The 1.8-ft gage datum discrepancy

The USGS stated in its November 5, 2008 letter,

The 1.8-ft gage datum discrepancy

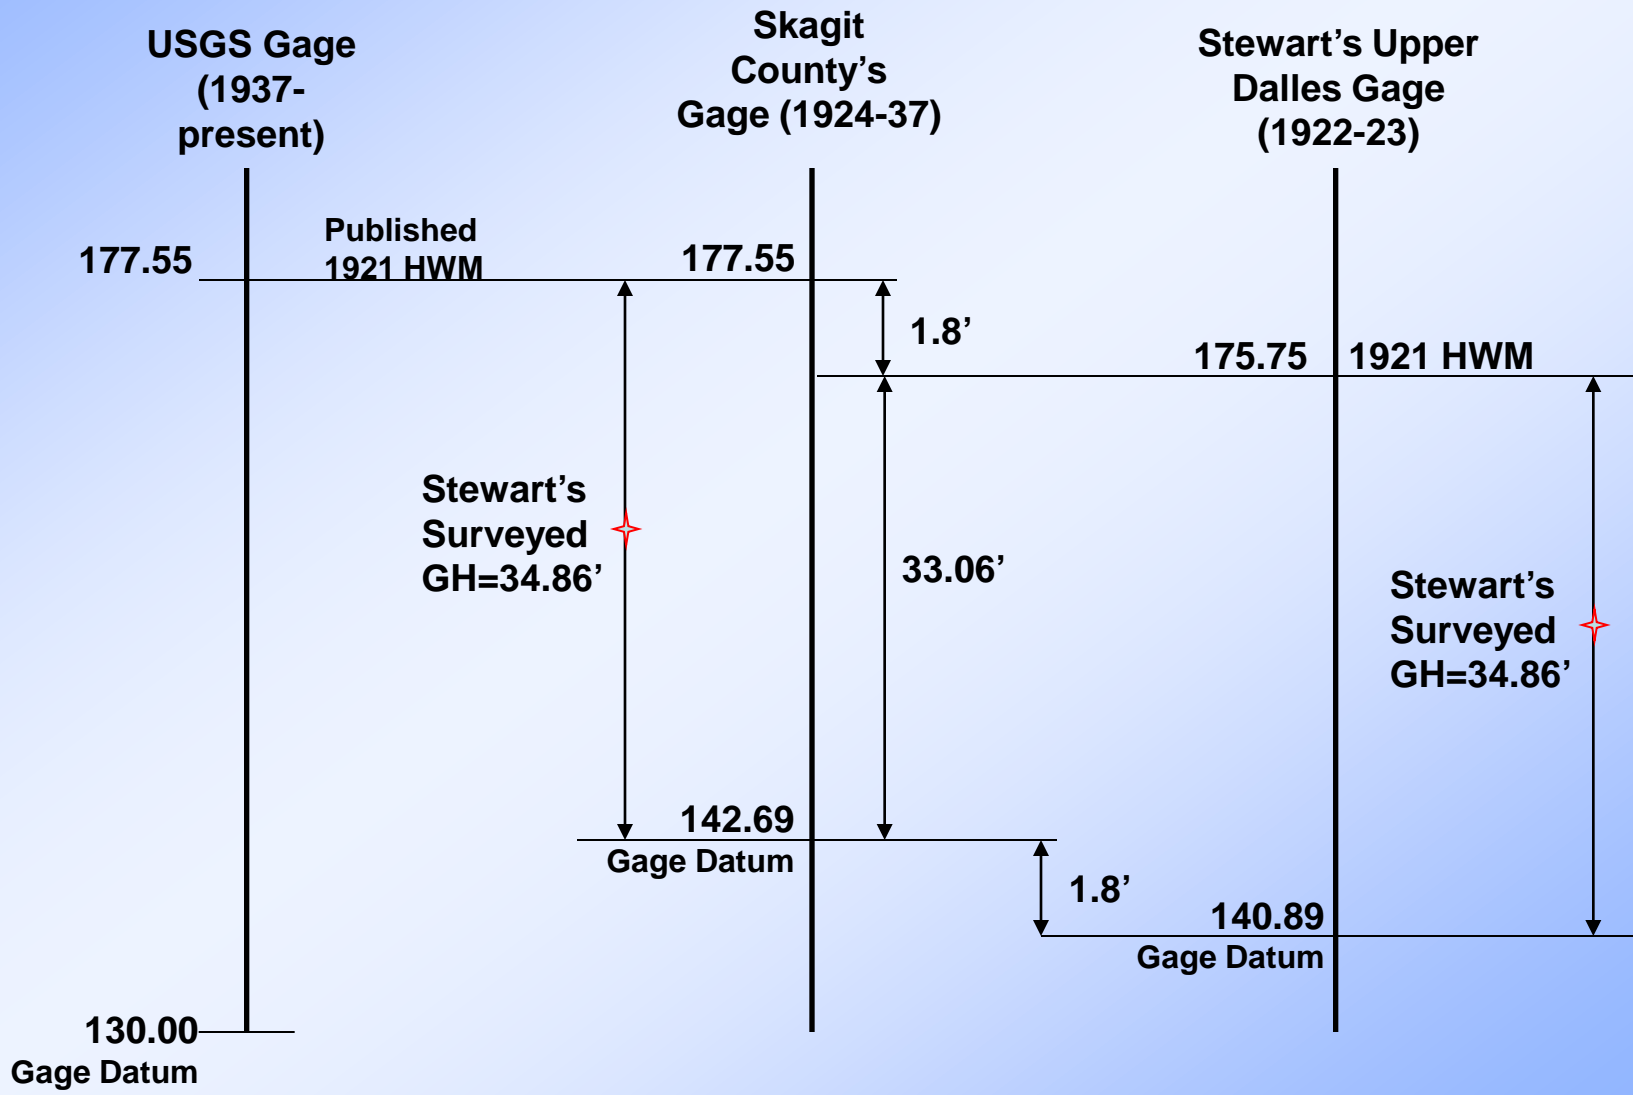
- 1.8 ft is the gage datum difference between Stewart's upper Dalles gage and County's old gage
- USGS looked for but could not find any record of the 1.8-ft datum conversion between Stewart's upper Dalles gage and County's old gage
